Pollard Street

Section 73 Addendum to Accompany
Design and Access Statement

December 2023

Hawkins\Brown

Roof Plan

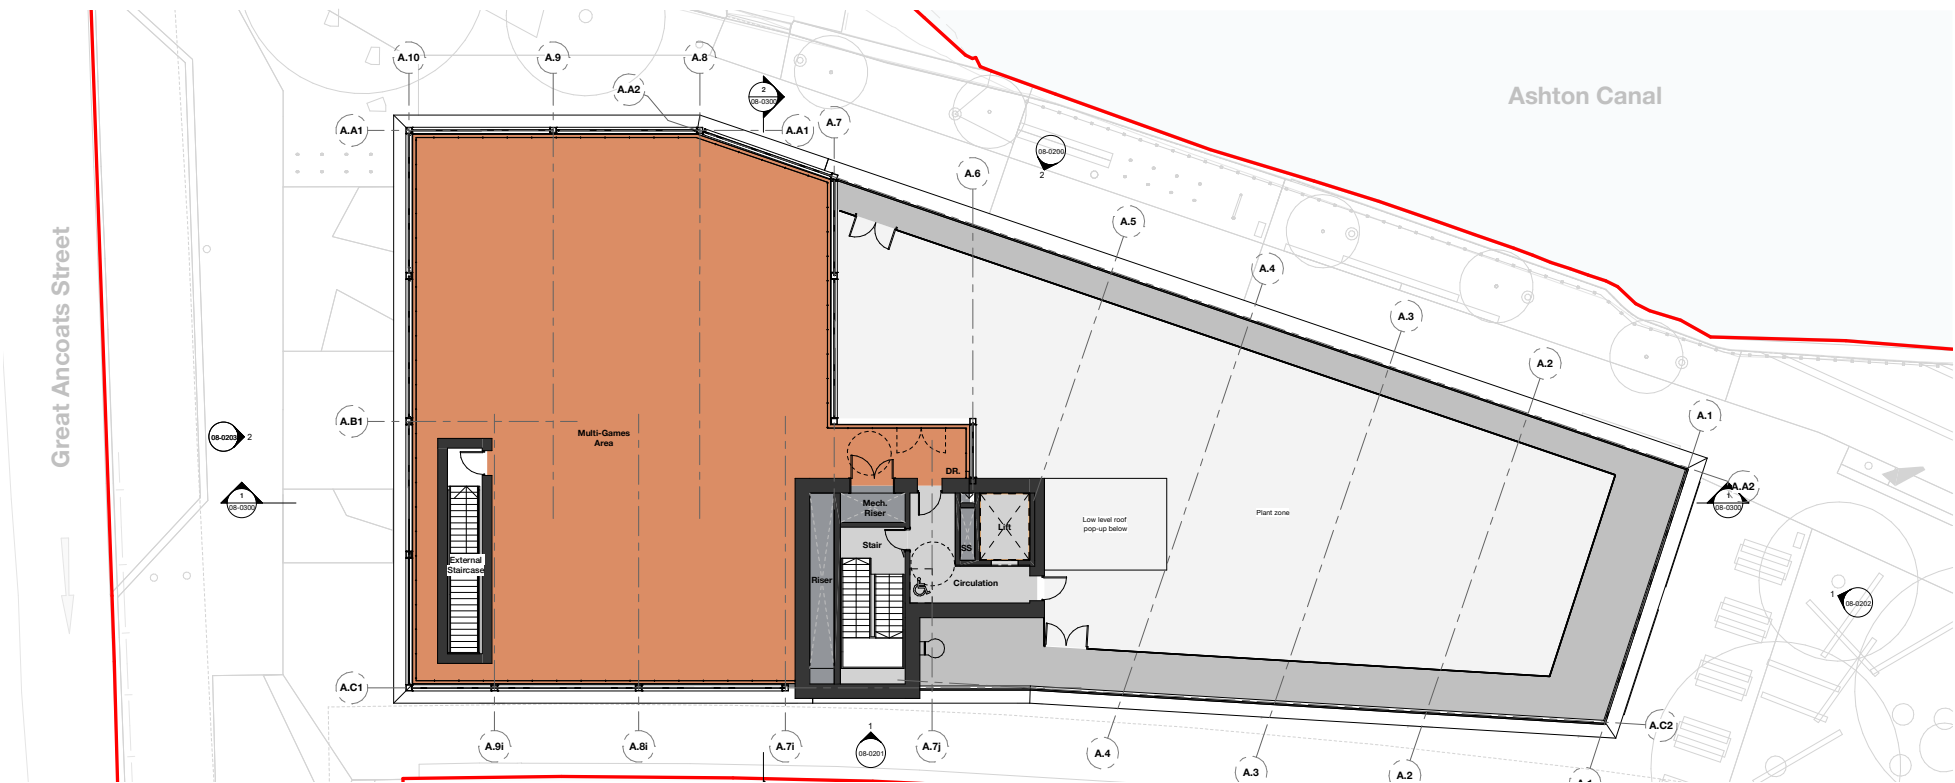
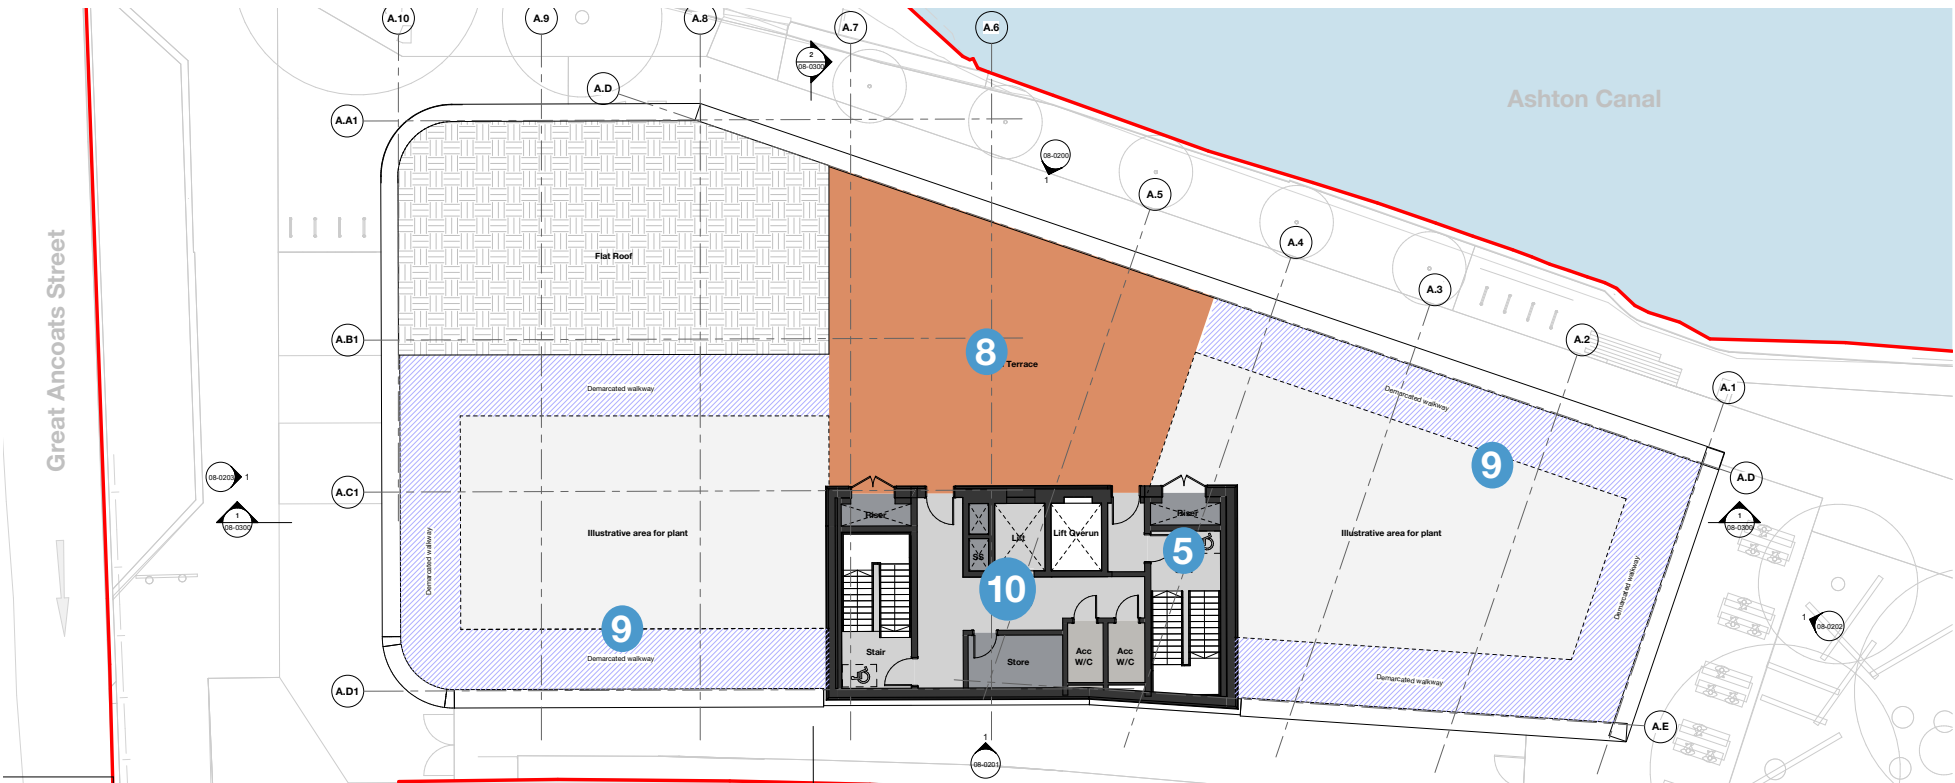
- 1. Primary façade cladding changed from metalwork to brickwork
- 2. Window arrangement updated
- 3. Main workspace entrance relocated
- 4. Ground floor access relocated
- 5. Second stair relocated within the central core
- 6. Internal layout updated
- 7. External gantry / access deck omitted
- 8. Rooftop amenity relocated
- 9. Position of plant screen updated
- 10. Roof access updated

First Floor Plan

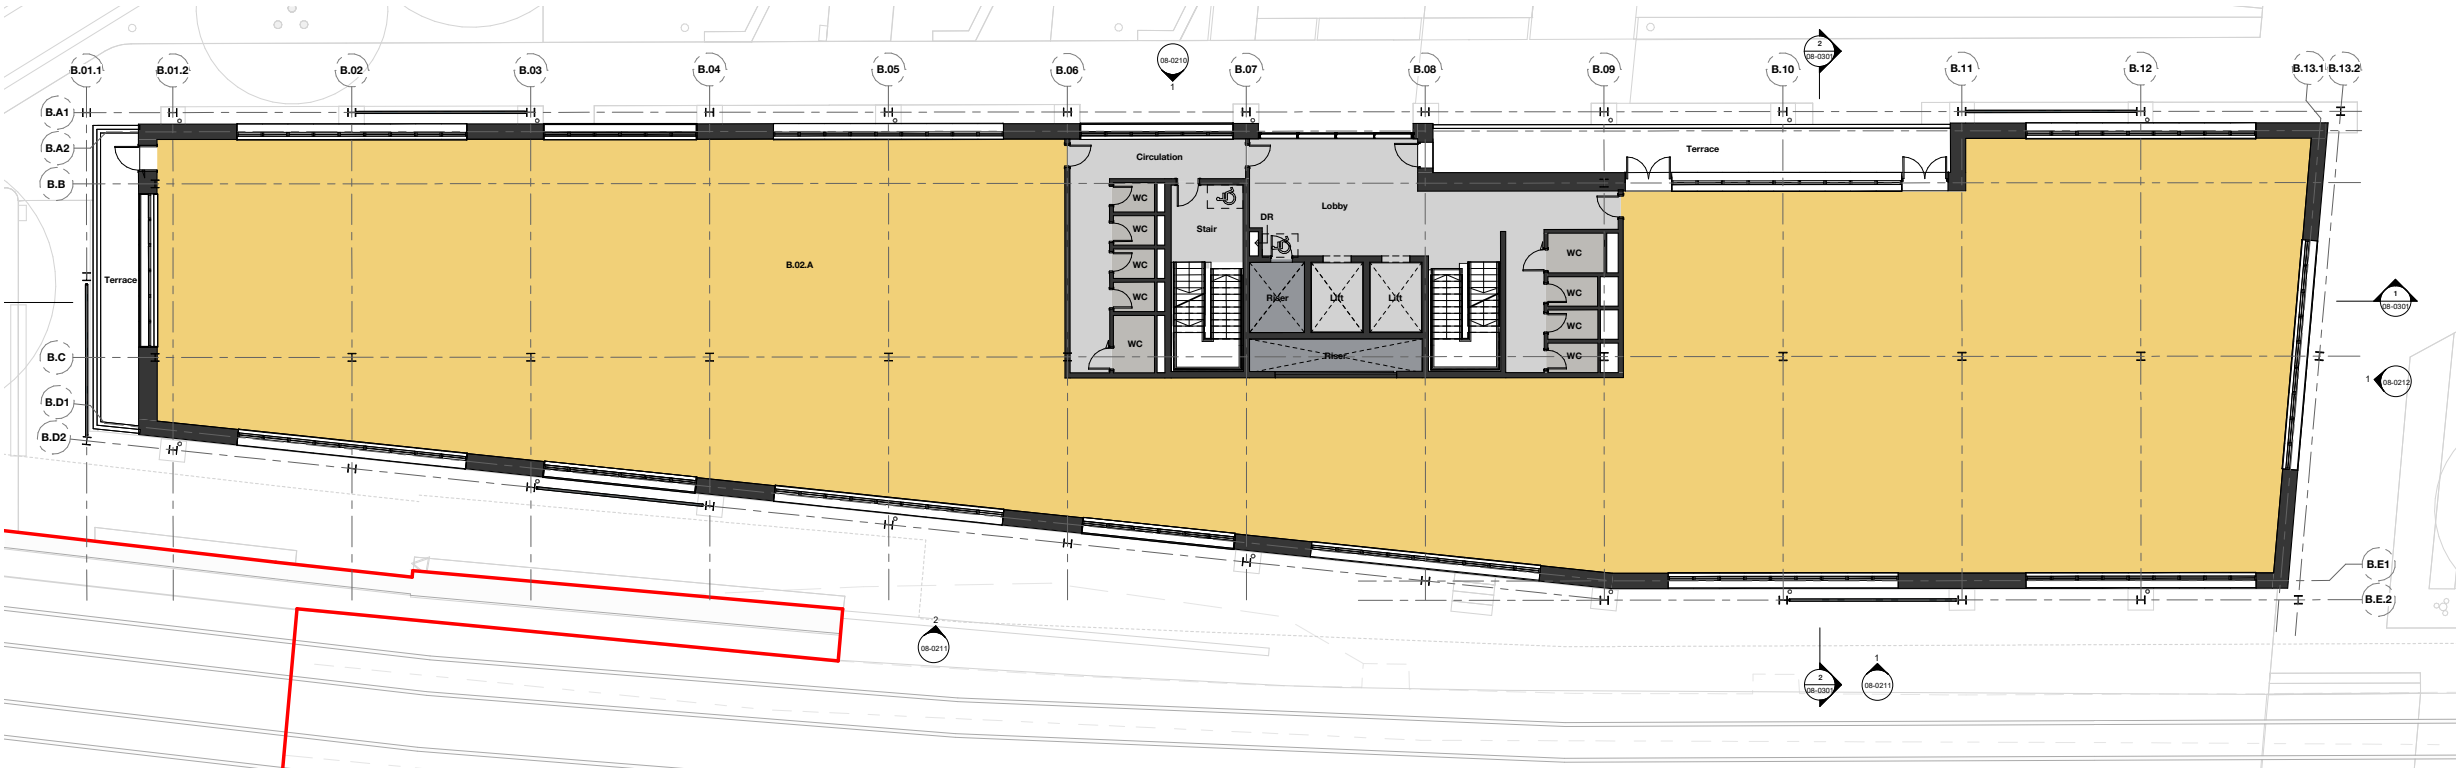
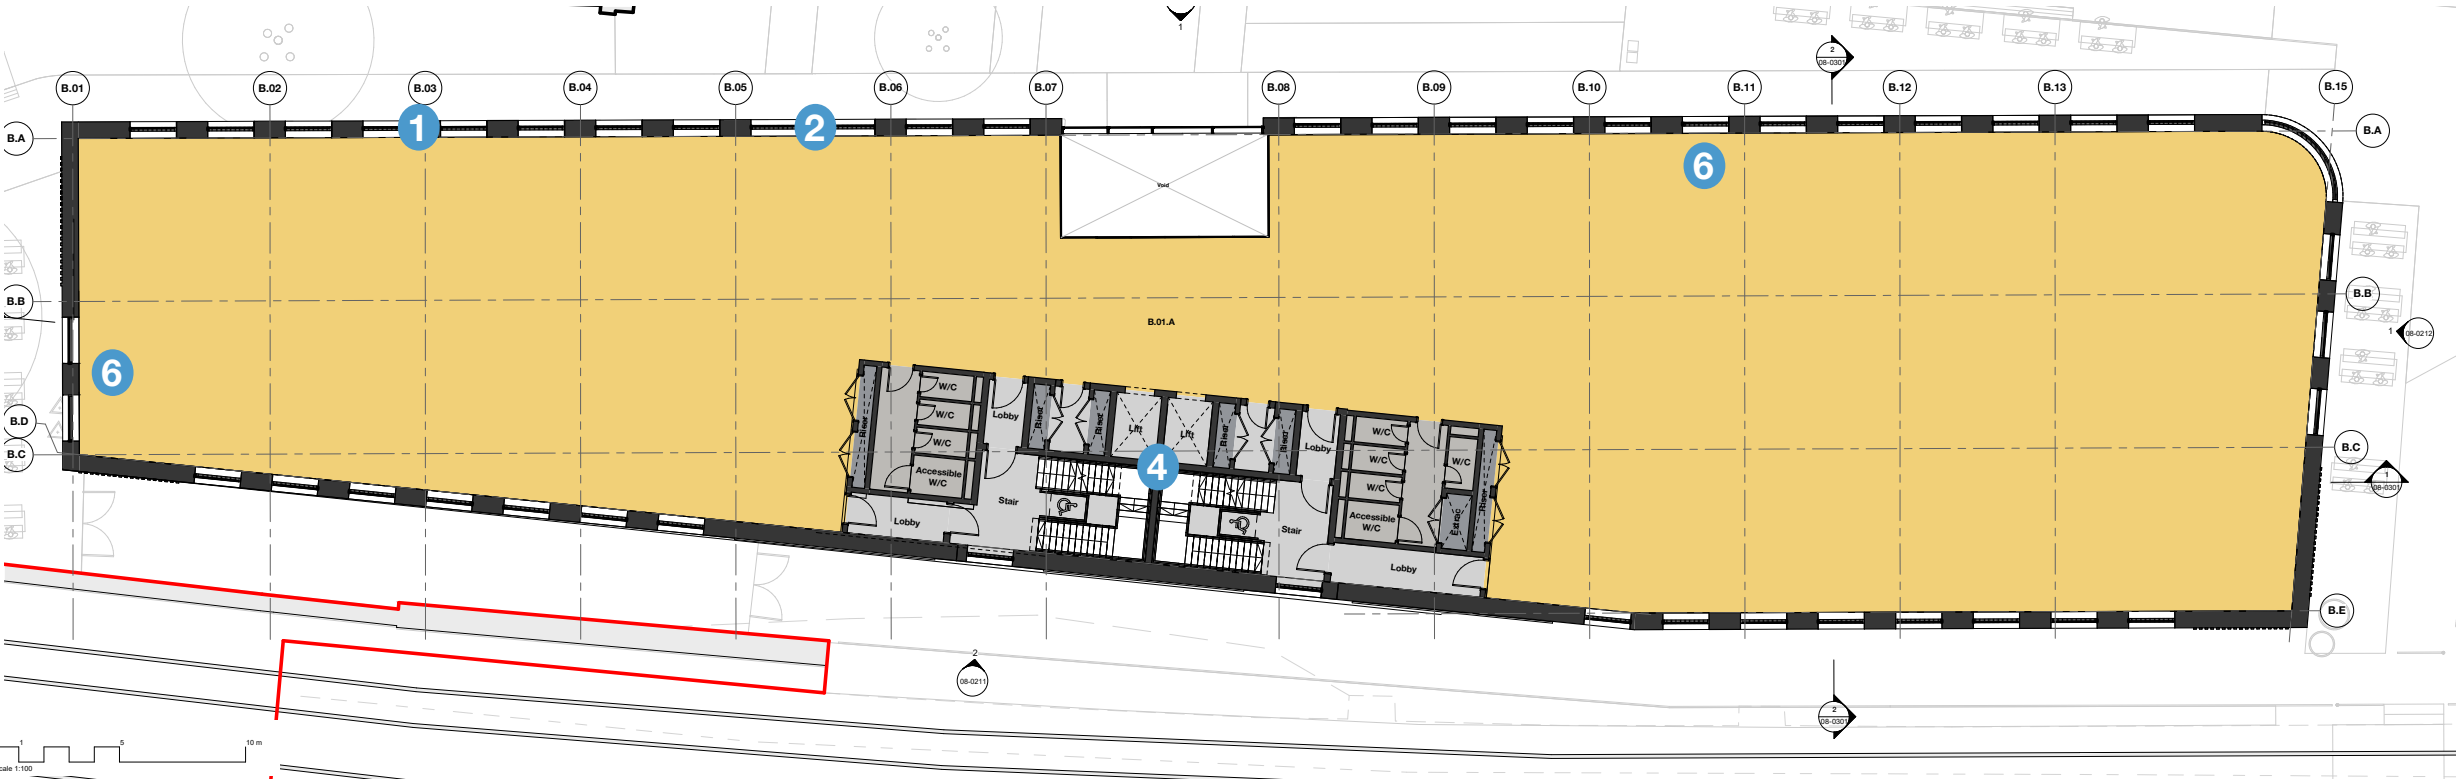
1. Primary façade cladding changed from metalwork to brickwork
2. Window arrangement updated
3. Ground floor access relocated
4. Core / circulation strategy updated
5. Internal layout updated
6. External gantry / access deck omitted
7. Position of plant screen updated
8. Roof access updated

Roof Plan

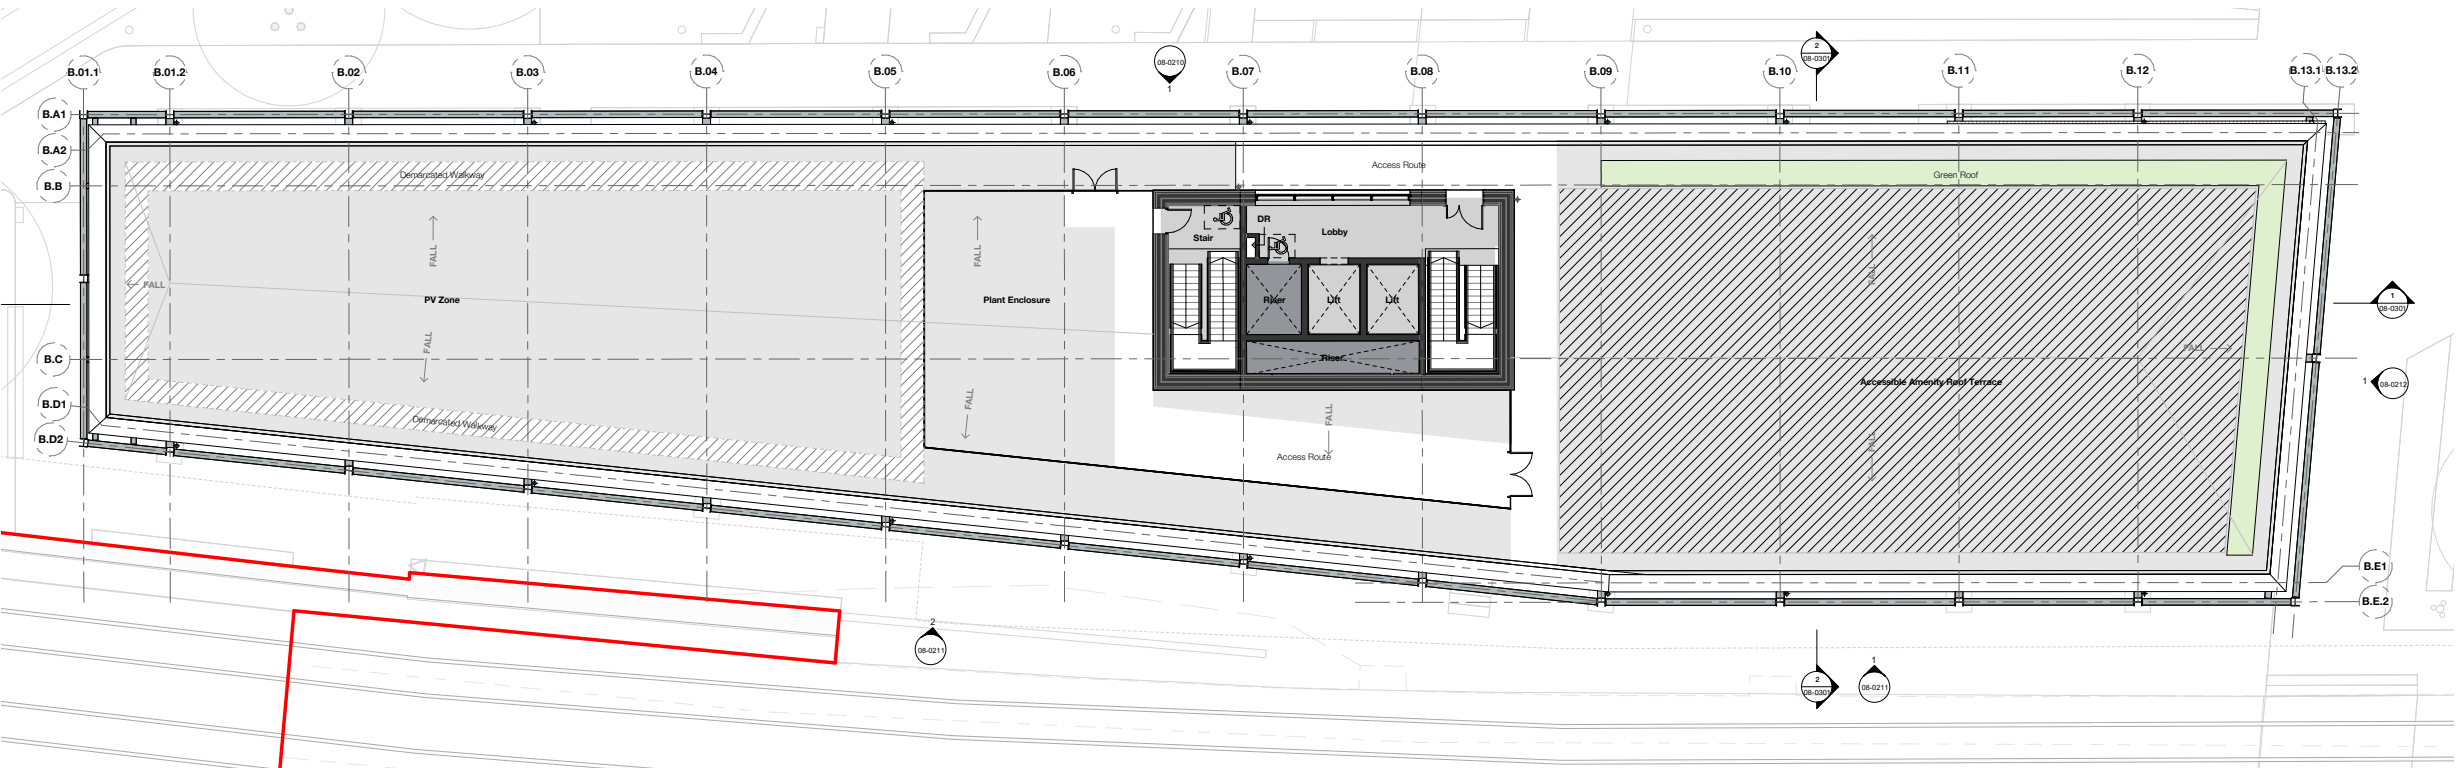
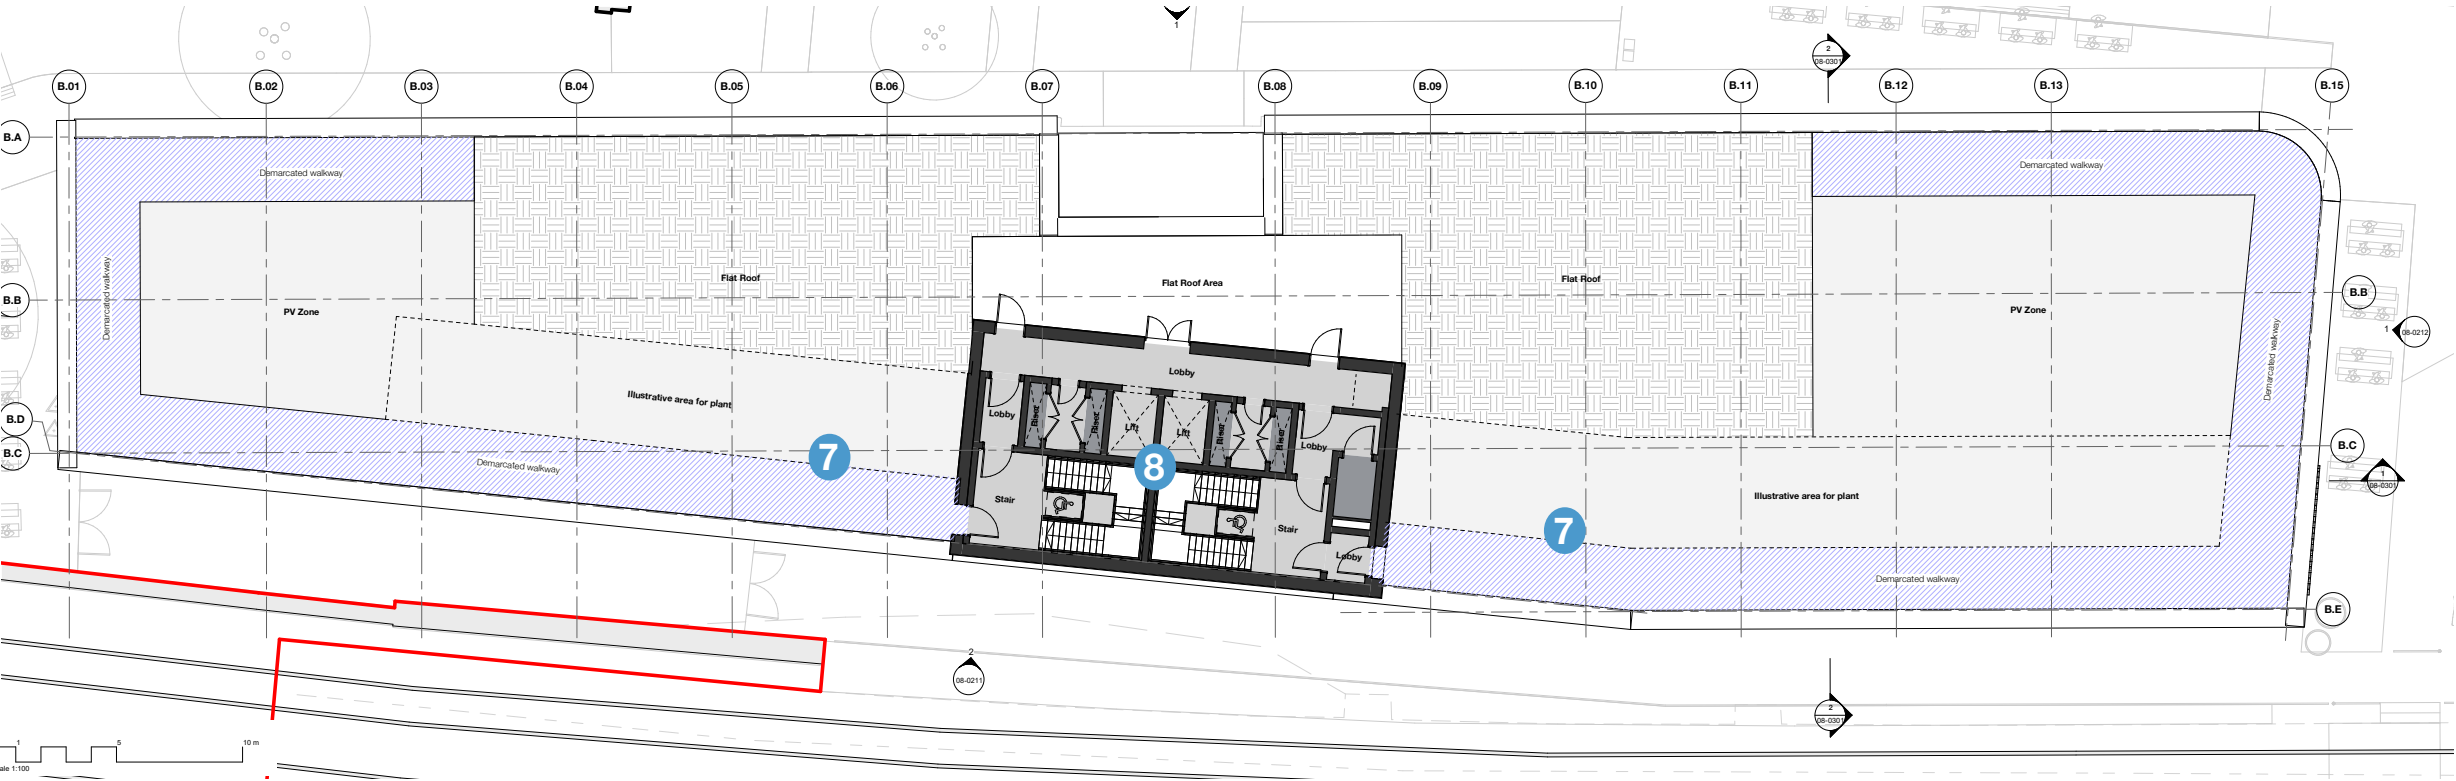
- 1. Primary façade cladding changed from metalwork to brickwork
- 2. Window arrangement updated
- 3. Ground floor access relocated
- 4. Core / circulation strategy updated
- 5. Internal layout updated
- 6. External gantry / access deck omitted
- 7. Position of plant screen updated
- 8. Roof access updated
